This anomaly sheet describes the known bugs, anomalies, and workarounds for the [ADF7023](#) transceiver and relates to Silicon Revision 2.2, which has corresponding silicon revision readback codes of 0x70, 0x23, 0x02, 0x02. See the [ADF7023](#) data sheet for details on how to read the silicon revision codes.

### ADF7023 FUNCTIONALITY ISSUES

**Table 1. Crystal Oscillator Low Frequency Spurs [er006]**

Figure 1. Recommended Crystal Oscillator Configuration

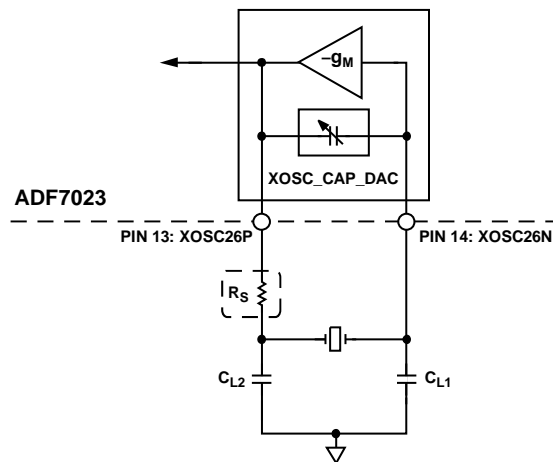
<b>Background Issue</b>	Under certain conditions, low frequency spurs can be induced in the crystal oscillator of the <a href="#">ADF7023</a> . The crystal oscillator circuit of the <a href="#">ADF7023</a> can exhibit spurs under certain conditions. These spurs are evident at RF at an offset frequency of approximately 7 kHz to 8 kHz. The spurs are more likely to occur with <ul style="list-style-type: none"> <li>• Reduced <math>C_{LOAD}</math></li> <li>• Reduced temperature</li> <li>• Increased XOSC_CAP_DAC value</li> </ul> These spurs do not occur in the condition where the crystal input, XOSC26N, is driven by an external source. See the <a href="#">ADF7023</a> data sheet for details on configuring for crystal oscillator operation.
<b>Workaround</b>	Introducing a series 150 $\Omega$ resistor on Pin 13 XOSC26P ( $R_S$ in Figure 1), together with limiting the XOSC_CAP_DAC setting to a maximum value of 4, will eliminate these spurs over the temperature range of the device.
